Magic Works Ltd

8/54 Jhalpaza, 10 Hobirbari Mymensingh, Bhaluka, Mymensingh, 2240
(24.342420, 90.419369)
29 January 2023

Observations

Table 4.1-1: Bearing Capacity Check for Isolated Footings considering 63 psf Live Load

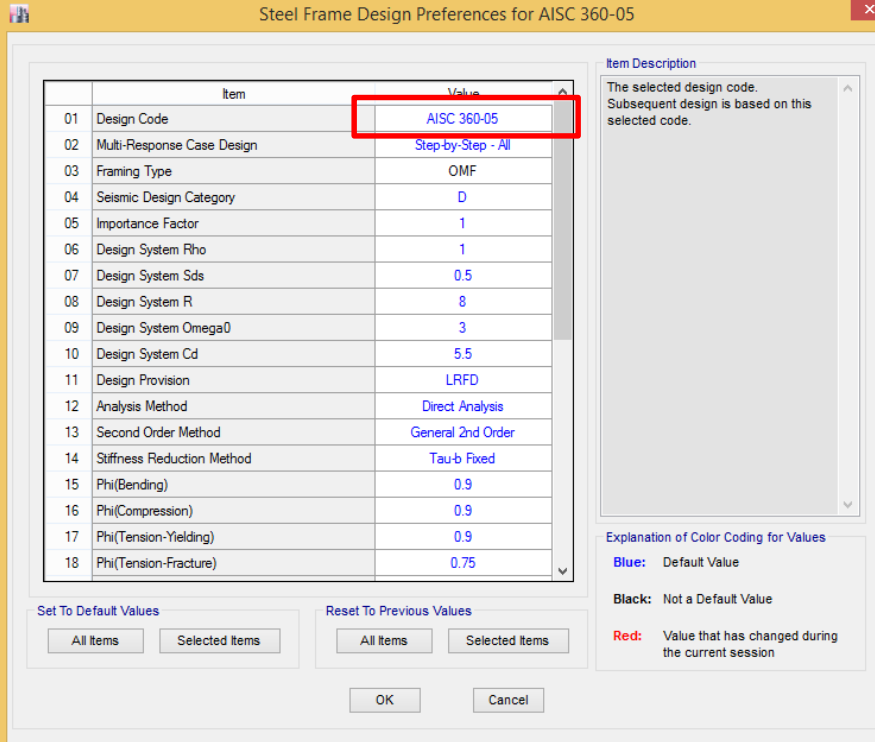
Building engineer has considered FoS 2 in foundation adequacy check however as per BNBC the FoS of footing is 2.5 and few foundation have FoS below 2.5. Building engineer is required to review the design of foundation as per BNBC requirements.

Discrepancy in as built drawing

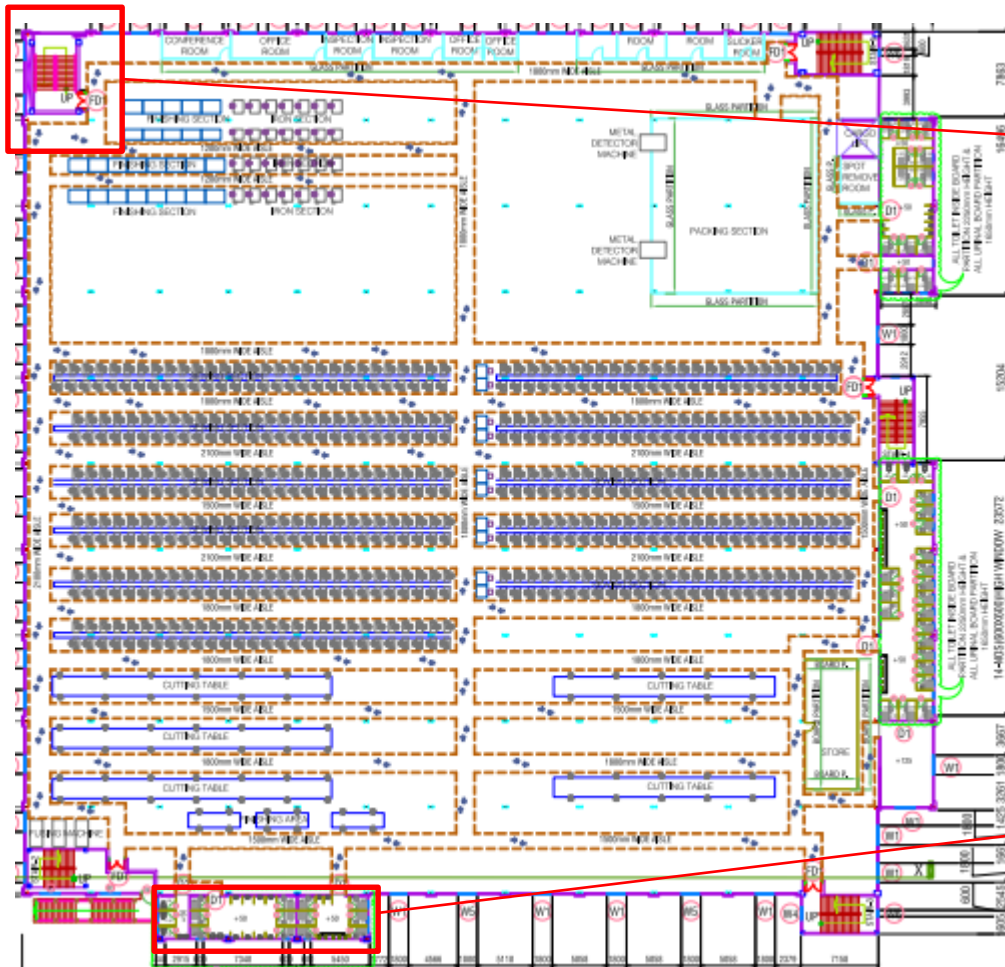
Stair was found demolished.

200 mm build up found at toilet

Unstable bamboo support on the demolition works which may slip away anytime.

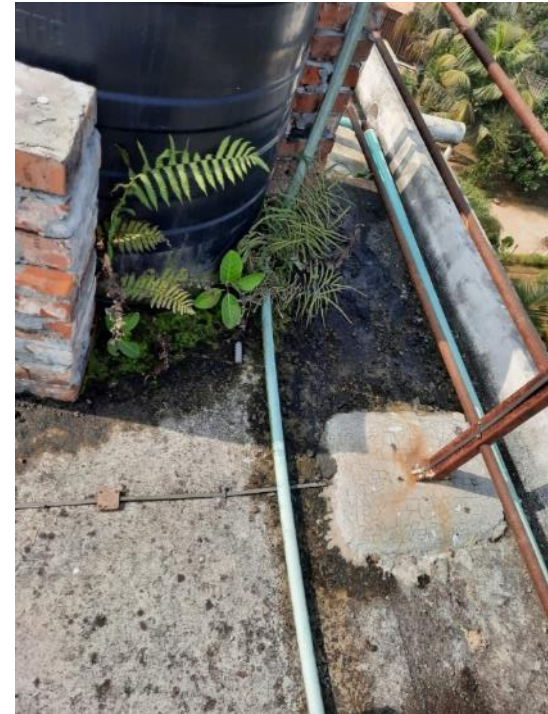
Corroded and deflected steel member support instead of lintel

Lack of demolition safety practice observed in the factory. Building engineer is required to follow the BNBC Part-7 chapter-4 for safe demolition works.

Severe corrosion on steel members

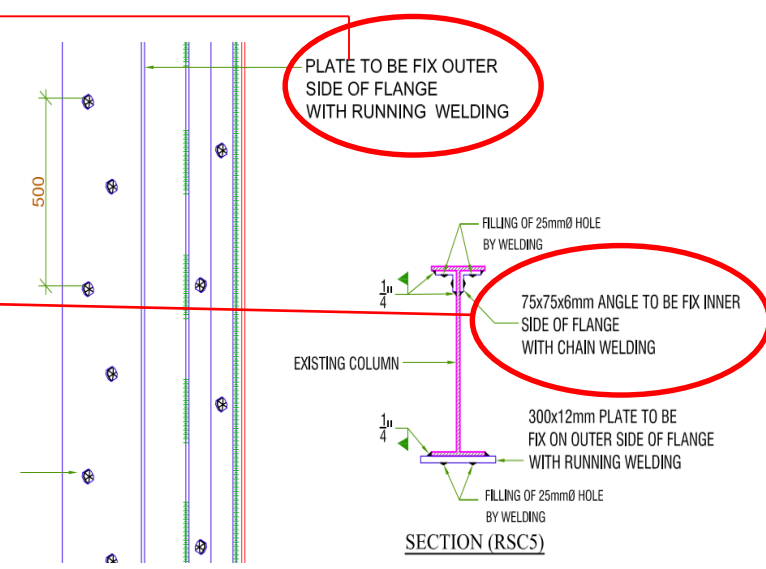
Severe corrosion was observed in steel members. Building engineer is required to remove the corrosion and provide rust proof paint on all steel members.

Moment resisting frame is only provided along short direction at 1st and 2nd floor

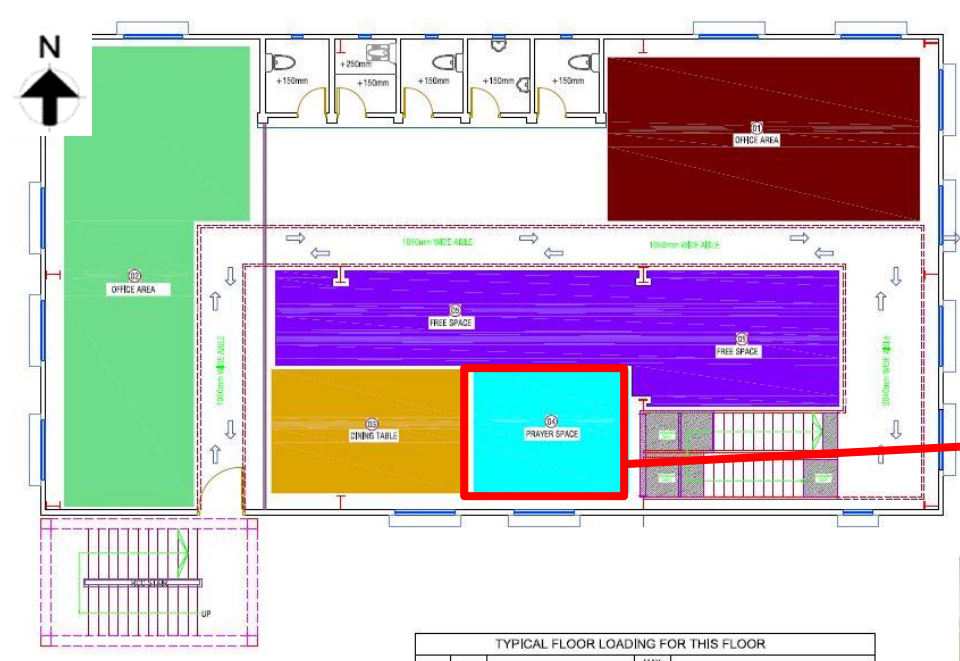
No wall bracing is provided along long direction at 1st and 2nd floor

Moment resisting frame is only provided along short direction and no wall bracing is provided along long direction at 1st and 2nd floor therefore lateral stability along long direction is questionable. Building engineer is required to check the lateral stability of the structure.

Deflection in steel deck slab (roof)

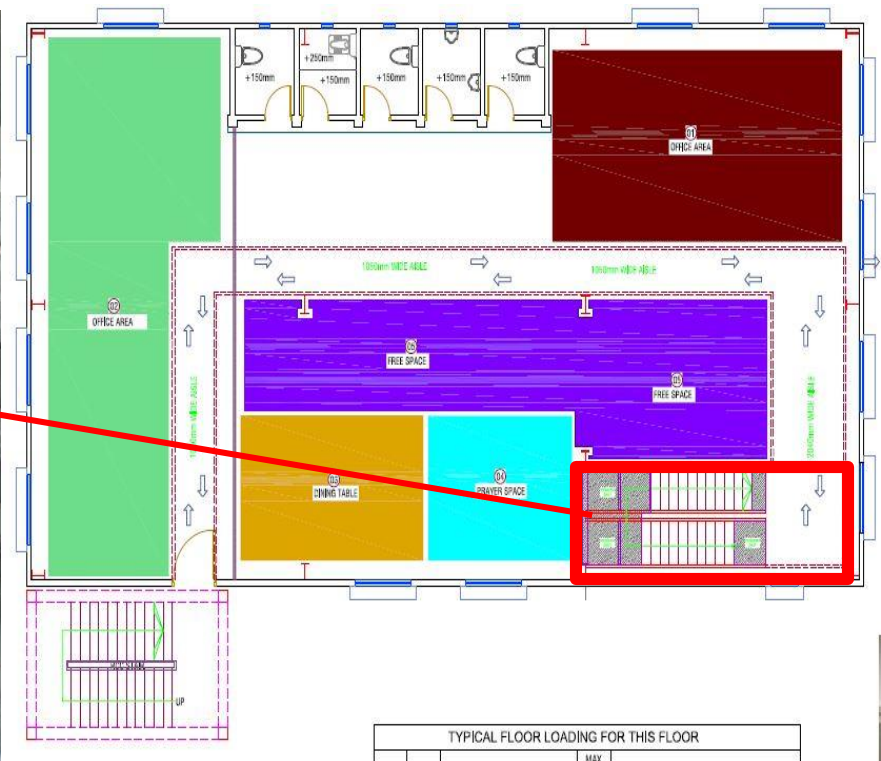
Deflection was found in steel deck slab (roof) at highlighted location. Building engineer is required to check the slab adequacy and propose remediation plan. Submit the remediation scheme to RSC for review.

Additional plate not installed in steel beam

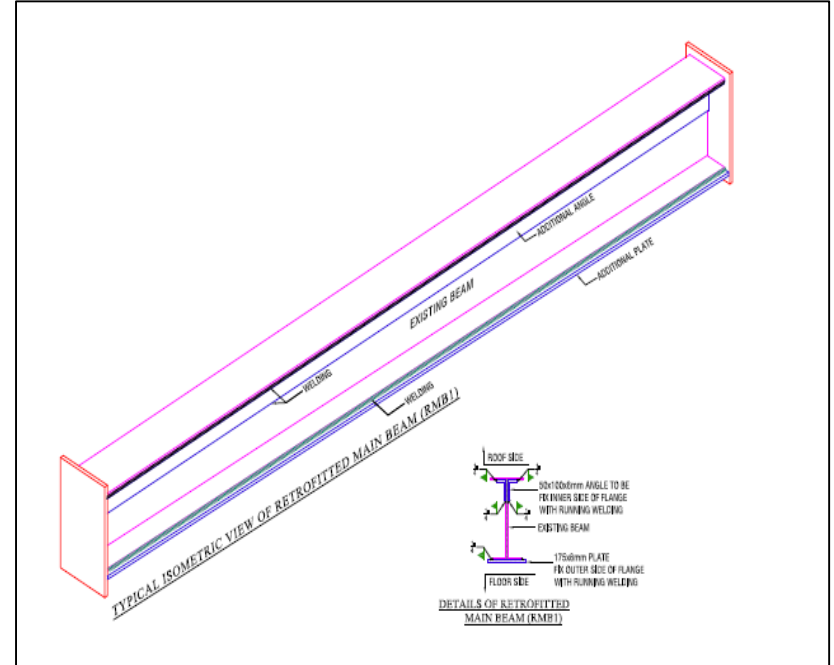
Additional plate is proposed for steel beam

Additional plate is proposed for steel beam (at roof) but not installed. However, the factory is required to submit retrofitting design along with Engineering Assessment (EA) to the RSC for review. Complete all remediation work once the EA is accepted from RSC.

**Significant gap in beam-column joint at
several locations**

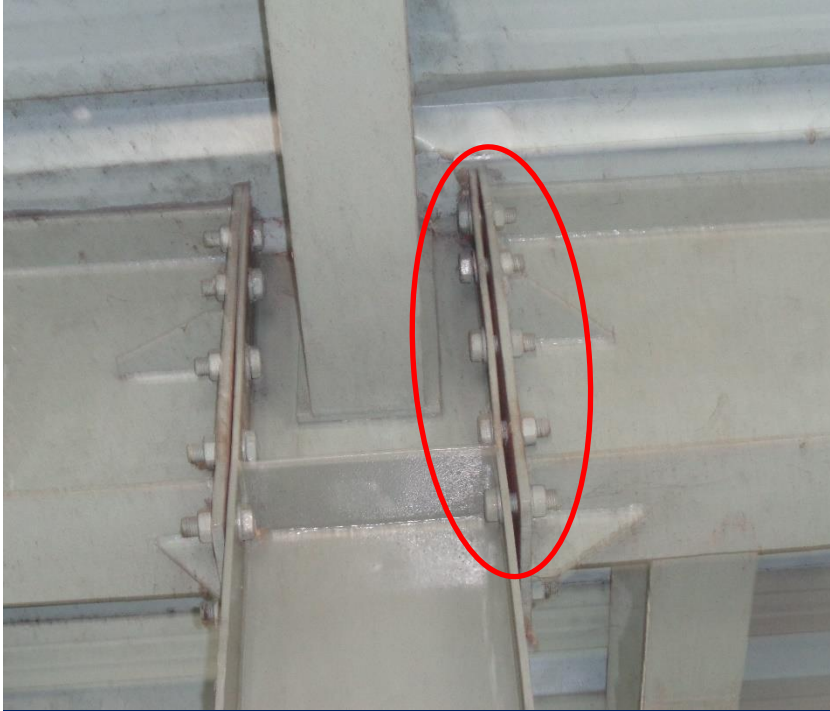
Significant gap in beam-column joint.

Significant gap was found in beam-column joint. Building engineer is required to identify all the connection gaps and fill the gaps with a suitable method.
